**ADDENDUM TO THE COMPOSITE ANALYSIS FOR THE E-AREA  
VAULTS AND SALTSTONE DISPOSAL FACILITIES**

WSRC-RP-99-00844

Revision 1  
March 28, 2002

**Figure 2.2-6 Schematic Diagram of No-flow and Prescribed Head Boundary Condition Specification**

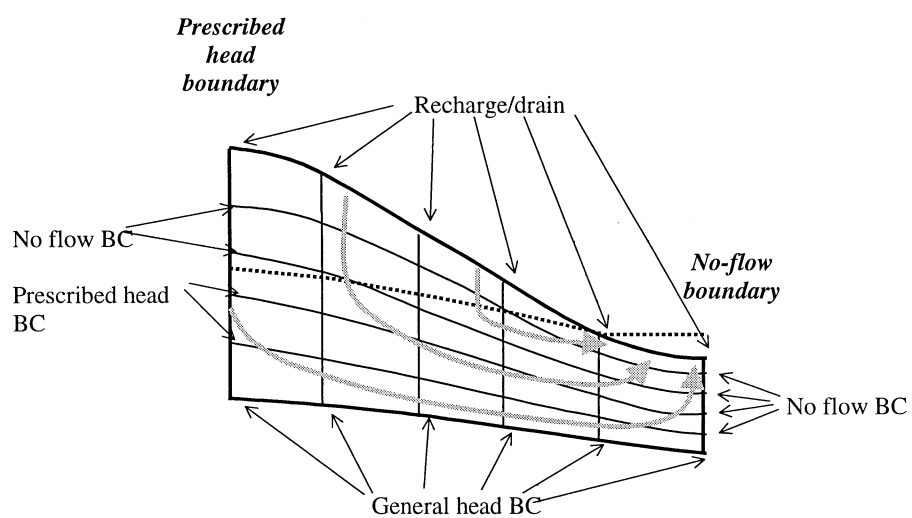
Condition	LFRG Recommendations	Response
	<ul style="list-style-type: none"> <li>Figure 2.2-6 makes the graphical presentation of velocity vectors pointing upwards. This figure should be revised to suggest water flows horizontally in the vicinity of the stream and not vertically.</li> </ul>	<p>No change has been made to the document based on this comment. SRS supports the hydrogeologic description of the conditions in the field as currently described. These conditions are similar to those described in Freeze, R.A. and J.A. Cherry, 1979, <i>Groundwater</i>, which provides additional credence for the description.</p>
	<ul style="list-style-type: none"> <li>On page 2-13 screening levels were set at 1 E-03, 1 E-04, and 1 E-05 below the maximum recorded inventories or contaminant fluxes. The justification for these differing screening levels is not provided. A single screening level would seem to be more reasonable.</li> </ul>	<p>Clarifying text has been added to page 2-10.</p>

Figure 2.2-6 schematically illustrates how model boundary conditions are defined along no-flow boundaries, such as UTR. As groundwater flow approaches the groundwater divide created by a stream, the flow turns upward and discharges to ground surface at seepage faces comprising the stream bed and/or adjoining wetland areas. This physical situation is reproduced in the model by assigning a drain boundary condition to the uppermost nodal layer and a no-flow boundary condition to underlying nodes, as shown in Figure 2.2-6. Therefore, no-flow boundaries actually consist of both drain and no-flow boundary conditions.

Figure 6.6-8 <sup>237</sup>Np Inventories for All Facilities Screened by Flux at Water Table

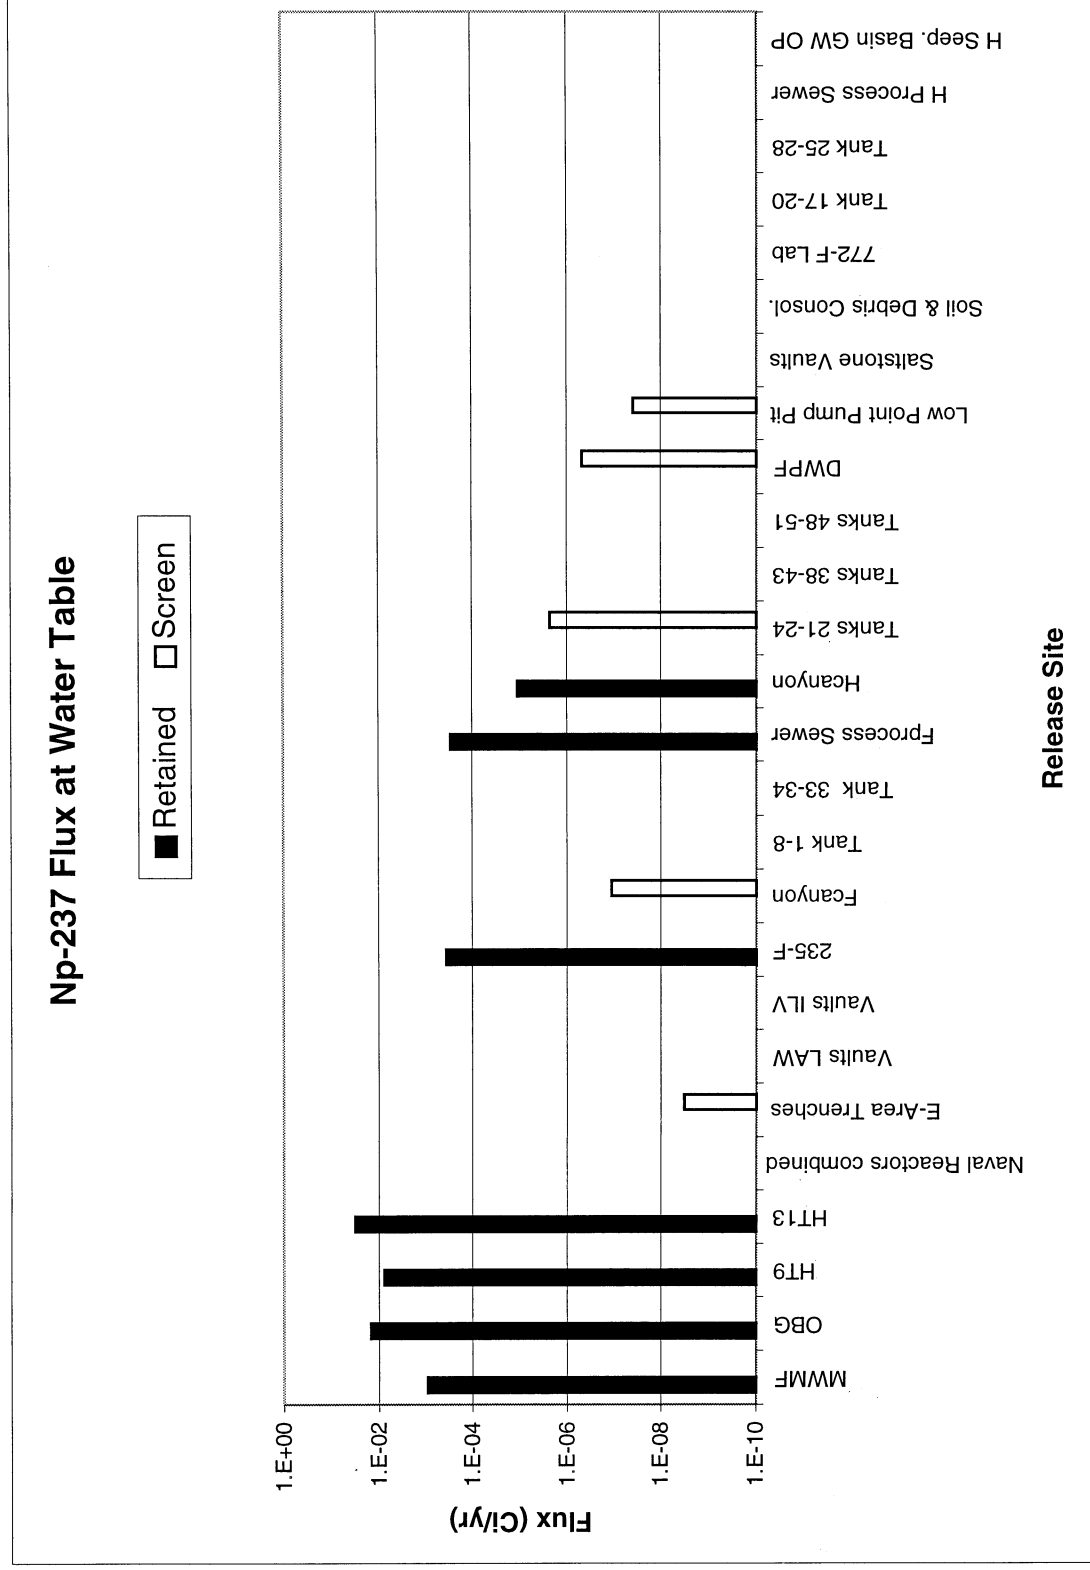
<ul style="list-style-type: none"> <li>Figure 6.6-8 screens out F-sewer, H-sewer, and H-seep without explanation or justification.</li> </ul>	<p>The figure presented in the Rev. 0 addendum had plotting errors for the facilities in question. A revised figure has been provided in the Rev. 1 addendum. In this revised figure, the F Process Sewer does not screen out. The H Process Sewer and the H Seepage Basin GW OP do screen out.</p>
	<ul style="list-style-type: none"> <li>In Table 6.6-4, footnote 14 screens out facilities that were added to the Composite analysis a few pages earlier. The apparent contradiction is not explained.</li> </ul>	<p>The actual peak flux value has been added to the table in place of the comment "Other Screen" and the unnecessary footnote has been deleted.</p>

**Figure 6.6-19 Peak Dose Histogram of  $^{14}\text{C}$  at FMB**

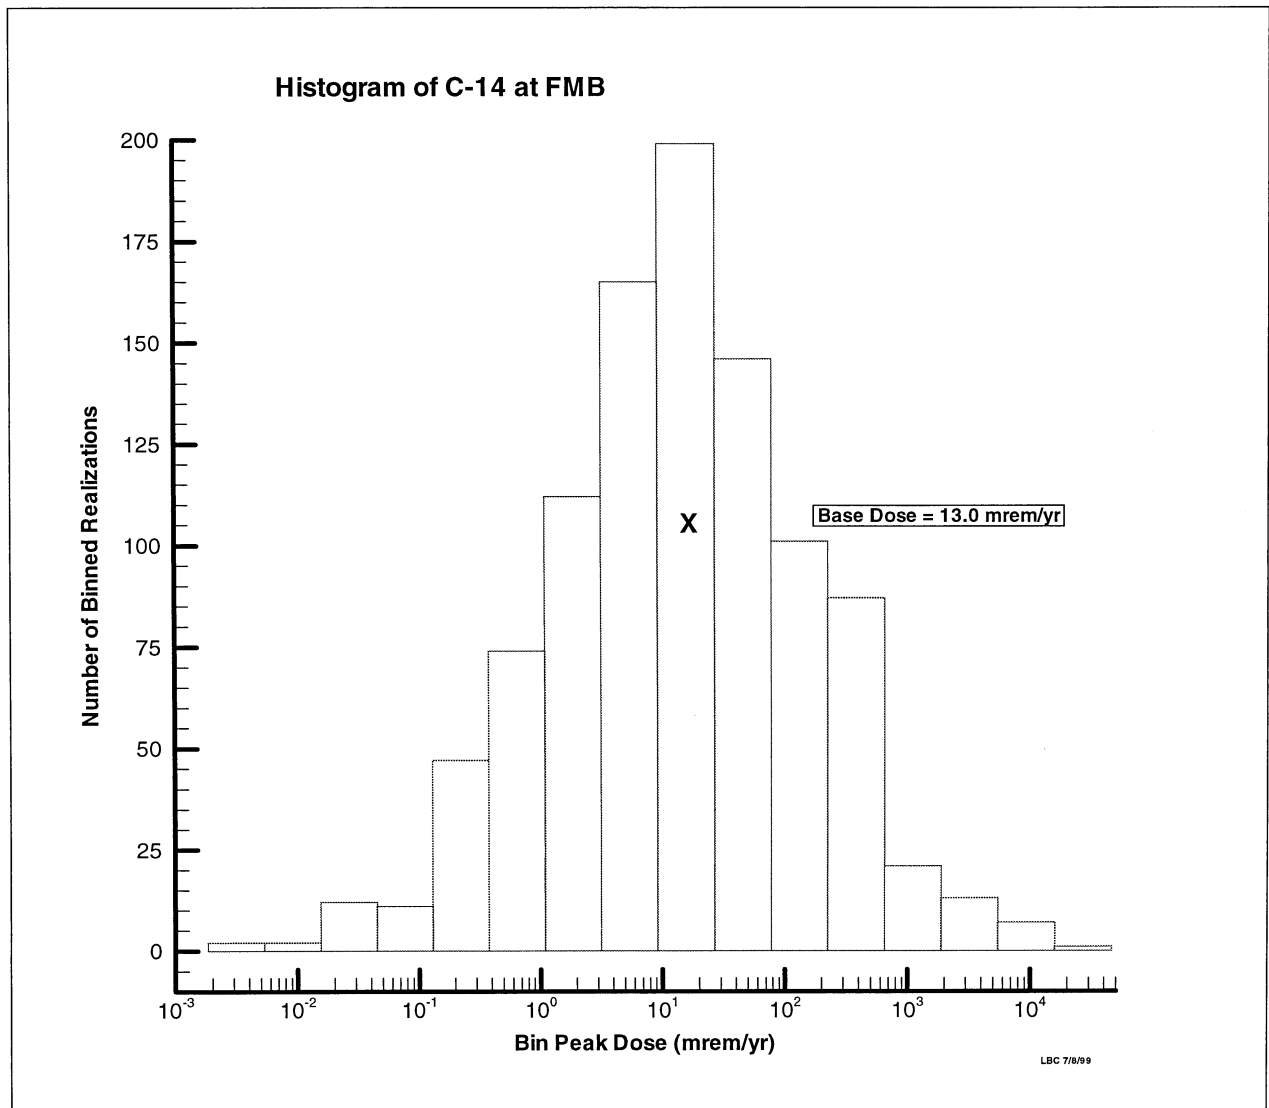
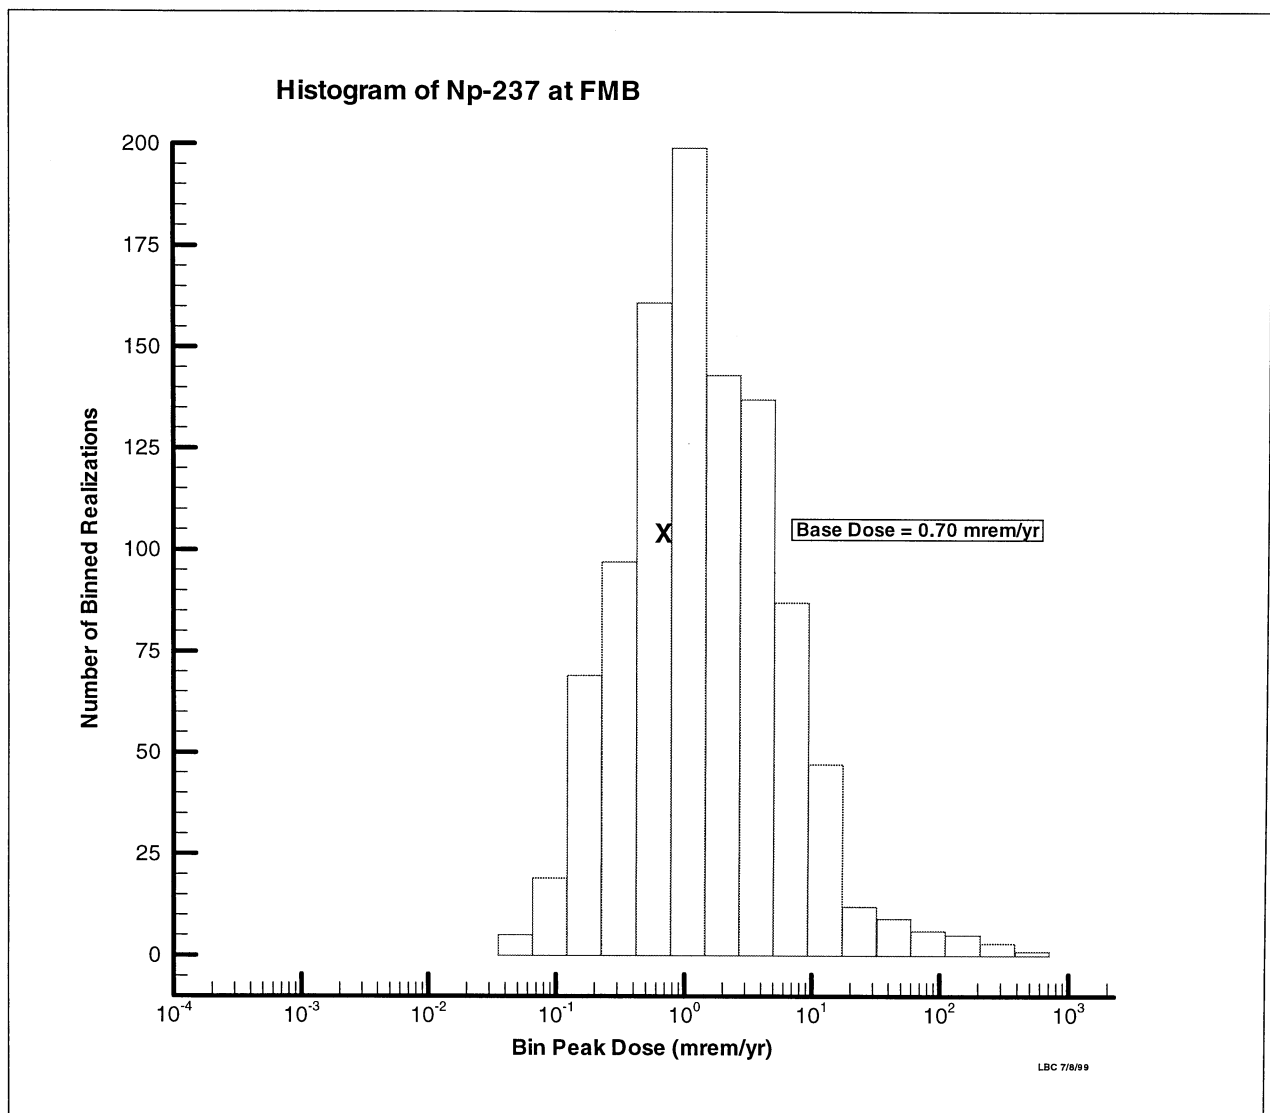
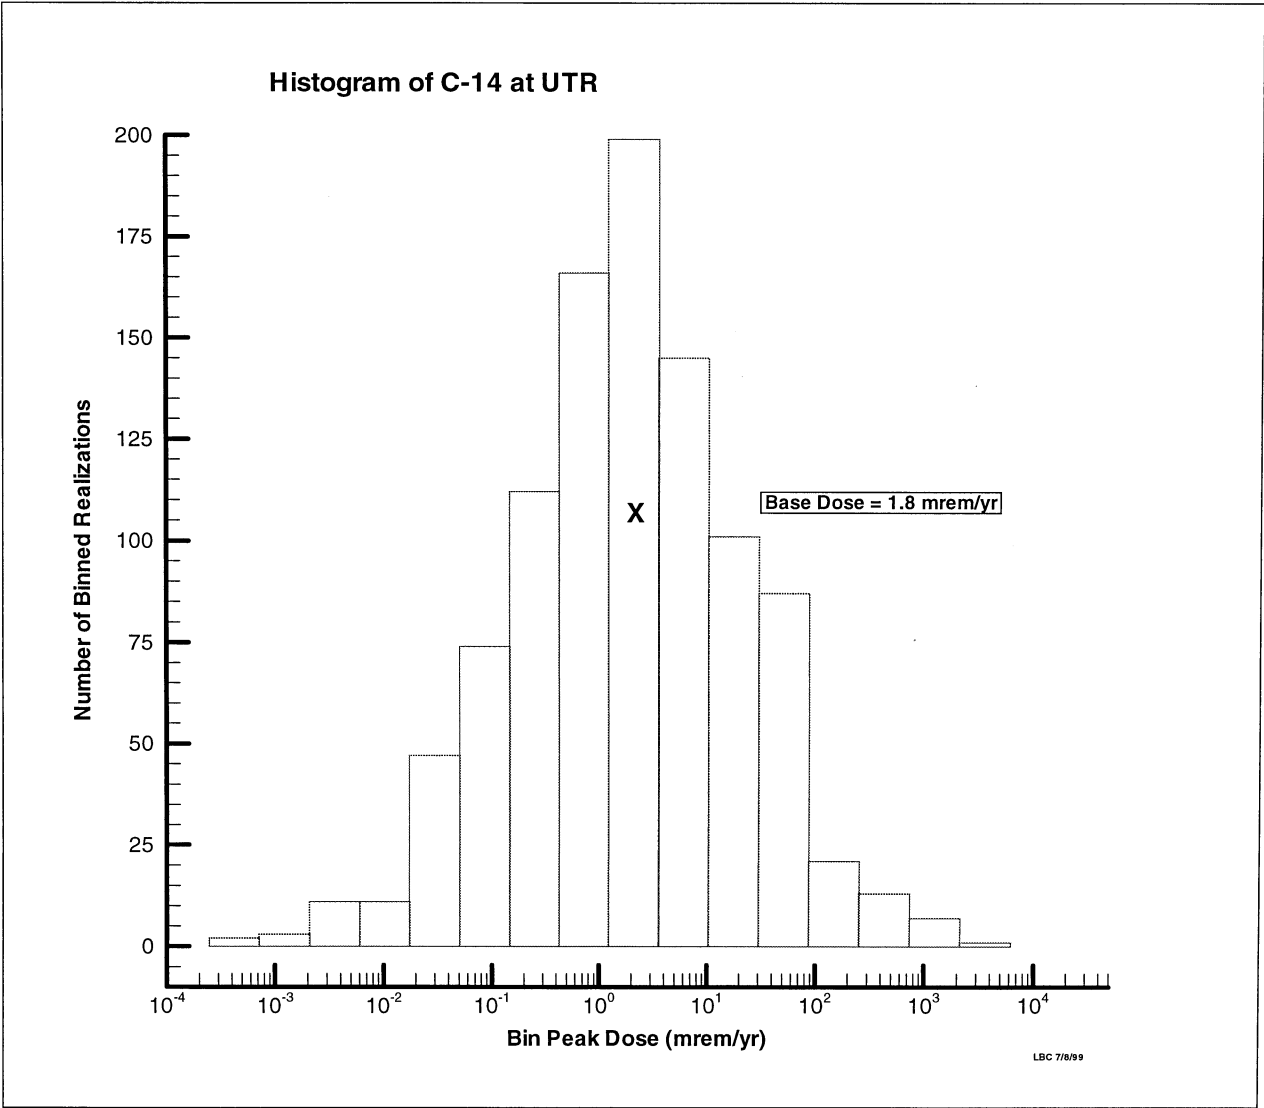
<ul style="list-style-type: none"> <li>Figures 6.6-19 to 6.6-21 show differing numbers of realizations exceeding the dose limit for different isotopes considered in the analysis. The significance of these results is not discussed or interpreted in the text on page 2-45.</li> </ul>	<p>The referenced text has been modified for clarification.</p>
